Peshastin Creek RM 4.3 Side Channel Reconnection Project

Project Sponsor: Chelan County Natural Resources Department - Design Engineer: Inter-Fluve

30% Designs Comment Matrix

November 2021

Mean Daily Discharge (2002-2020) [adjusted to include irrigation withdrawal]

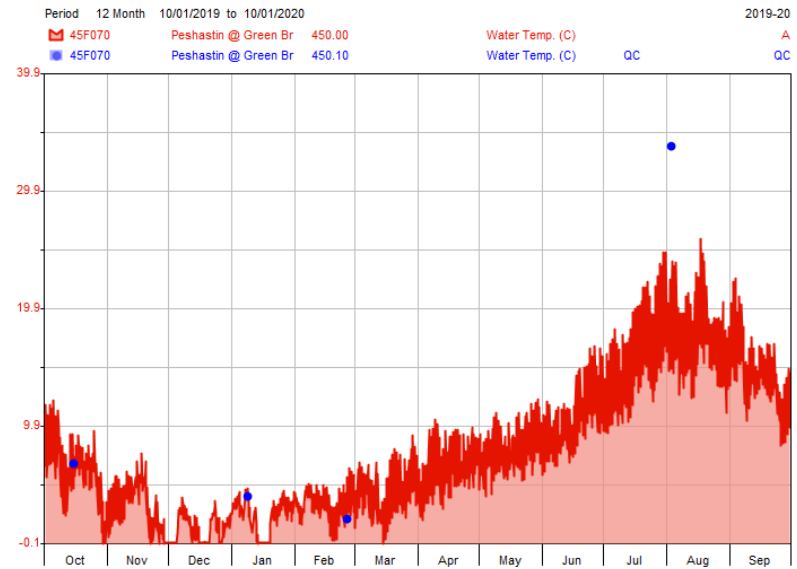
<p>Tributary Committee</p>	<p>18. There is concern that diverting flows into side channels when stream flows are low in Peshastin Creek will increase water surface area resulting in warmer water temperatures and reduced rearing habitat. It is important to maintain a certain flow in the main channel.</p>	<p>For the next design iteration, we have re-visited flow data and factored in the influence of the downstream irrigation diversion on gage data. For reference, the annual hydrograph has been attached at the end of this comment response log.</p> <p>In the 60% designs, the side channels will no longer be activated during the period of summer low flows when stream temperatures are most concerning. The lower side channel (and split flow channel) will only engage when flows exceed 45 cfs, and the upper high flow channel will connect at 550 cfs. This connection frequency should allow all of the flow to remain in the main channel during the period when summer temperatures are most concerning (Note: split flow channel #1 is being redesigned so that it will not be engaged during the summer low flow period and #2 has been dropped from the plans). As a result, the proposed project should not contribute to an increase in water temperature during summer low flow conditions.</p> <p>Review of historical flow and temp data at the Green Bridge Road gage (RM 1.4 - see example below) indicates that stream temps typically don't rise to a problematic level until flows drop below ~45 cfs. Mean daily flows usually drop below 45 cfs at the gage by mid-July, corresponding to water temp increase from ~15-20°C (daytime). However, it should be noted that the project site (RM 4.3) is located upstream of the Peshastin irrigation diversion (RM 2.5), and typical flows through the design reach do not drop below 45 cfs until early August (see hydrograph at end of comment matrix).</p>
